BUILDING F HVAC PENETRATION LAYOUT SUBMITTAL 12/15/2020

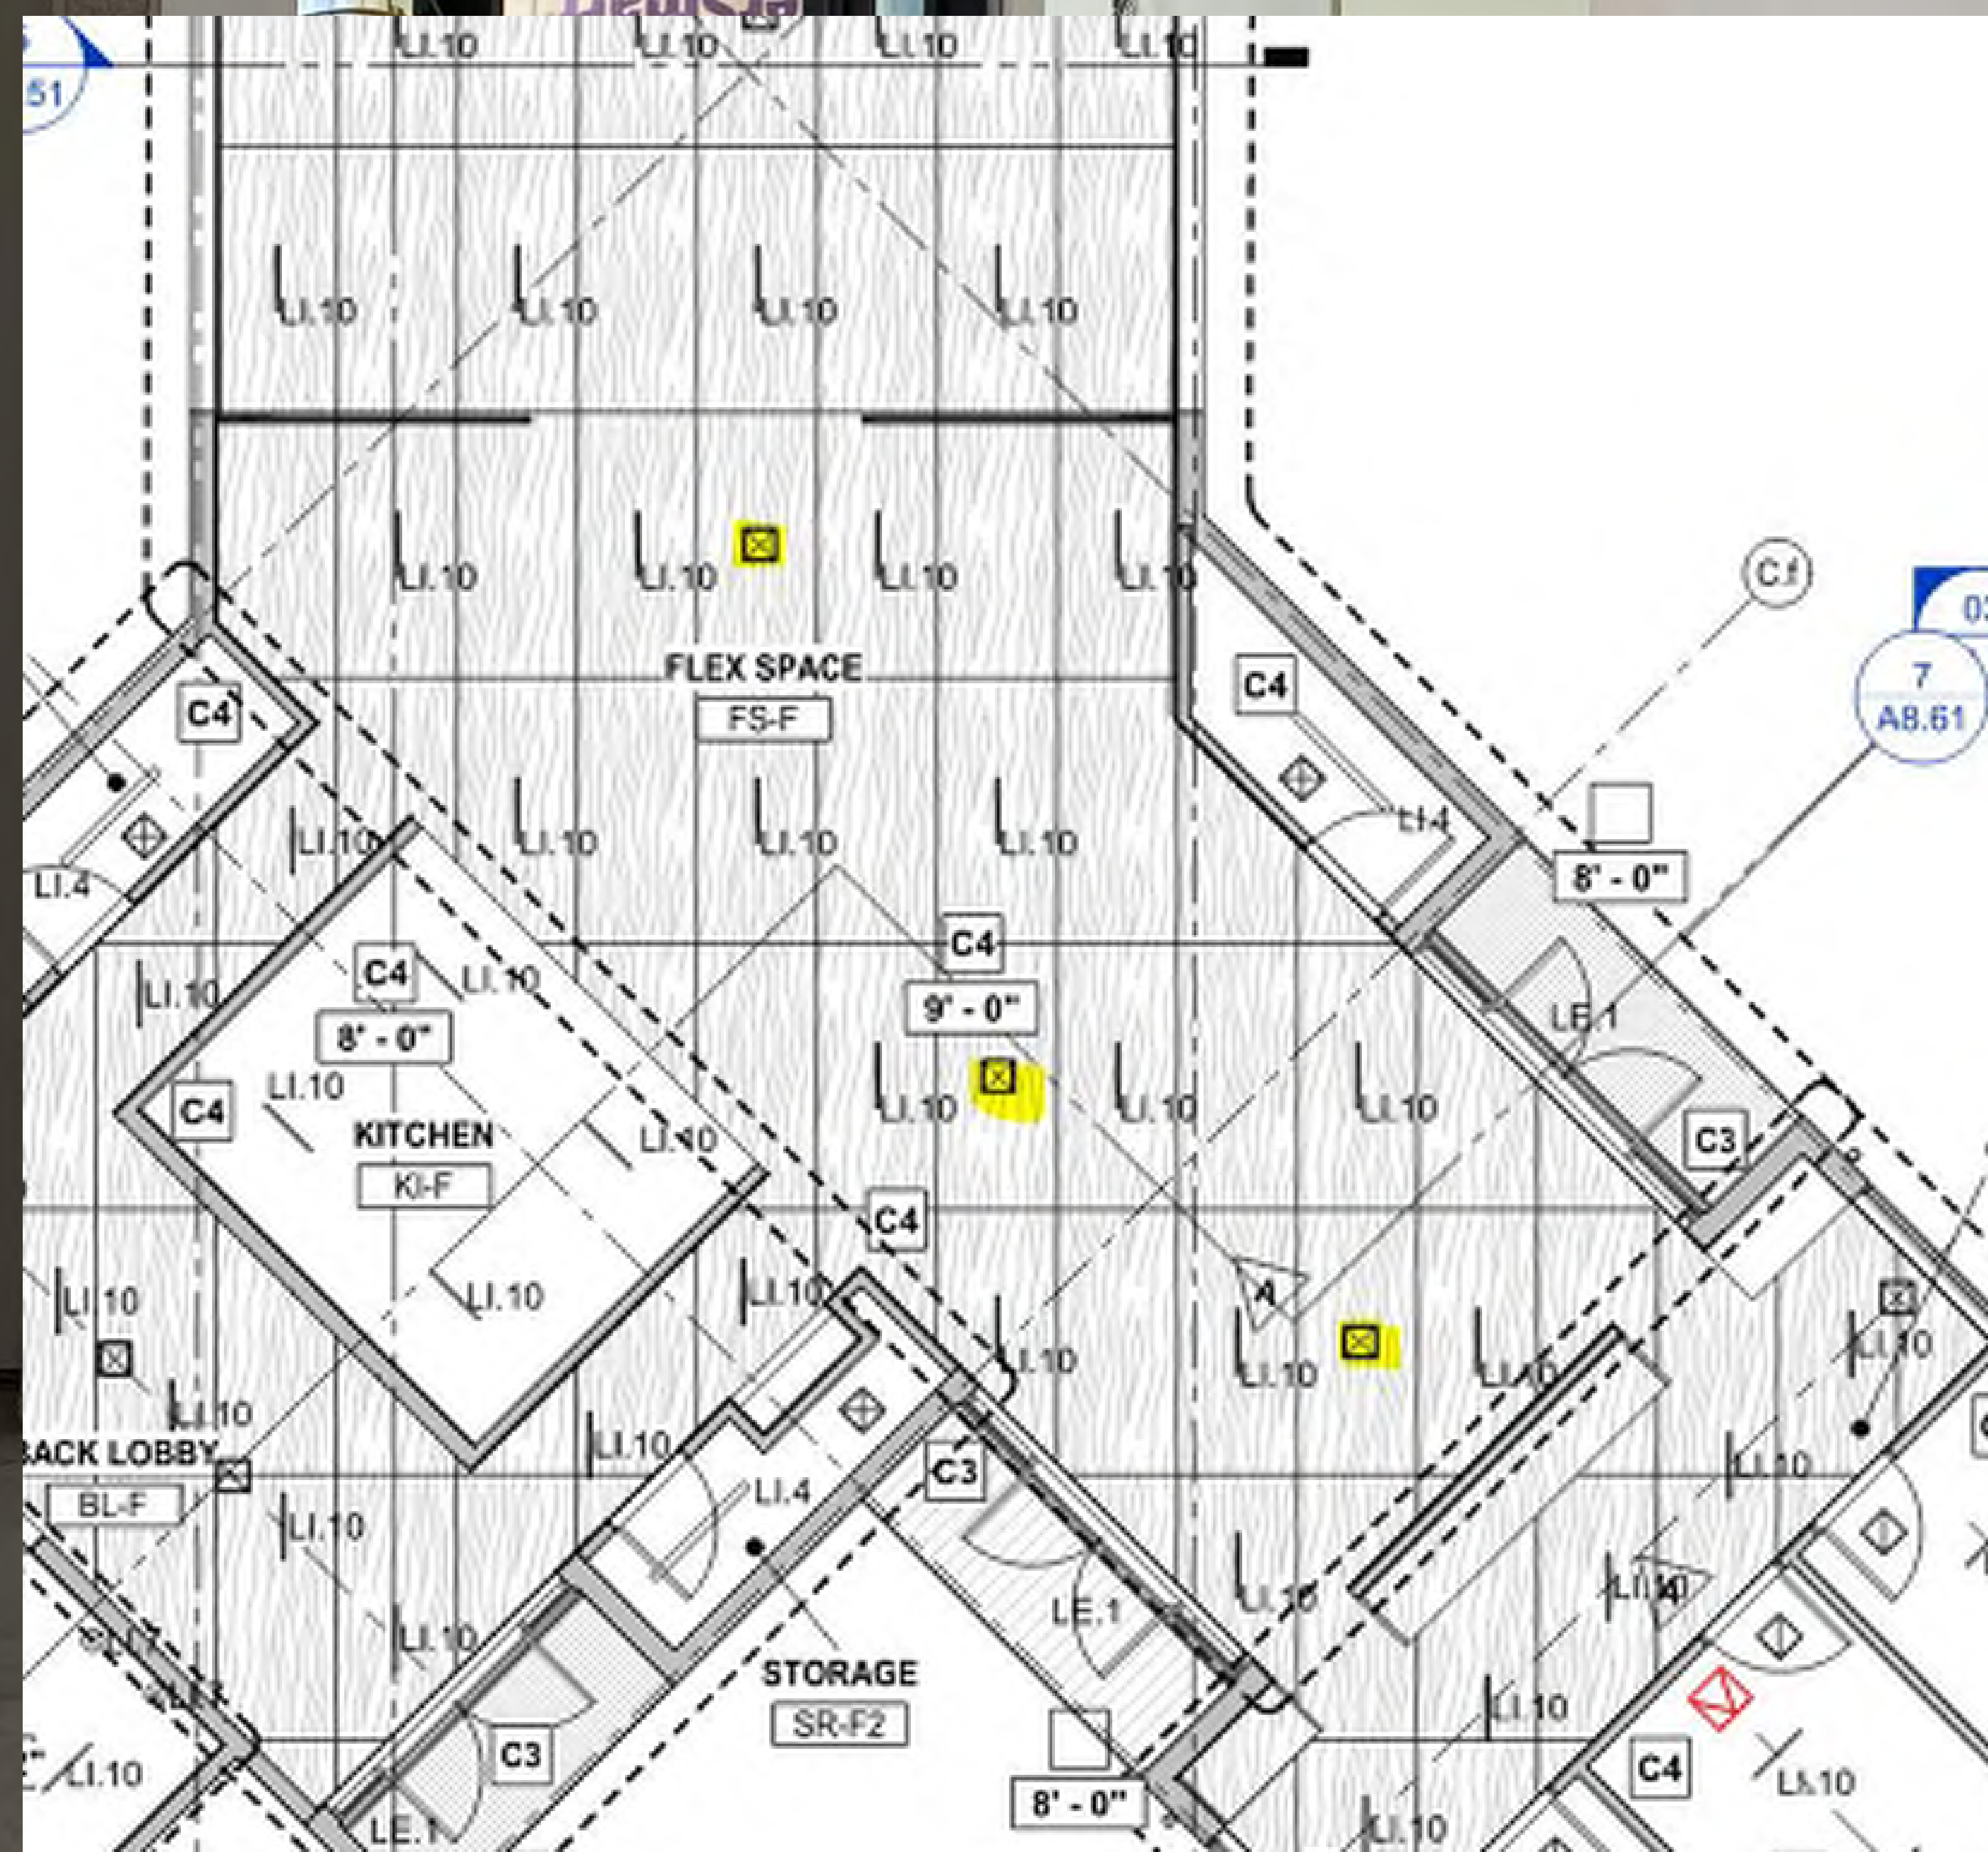
AS DISCUSSED ON SITE ON 04/08/2021, ALL HVAC IN BUILDING F SHOULD ALIGN WITH THE LIGHTS. THEY SHOULD BE AT THE SAME ANGLE AND EVENLY SPACED. SEE RCP ATTACHED BELOW FROM HVAC LAYOUT SUBMITTAL. REMOVE AND REPLACE.
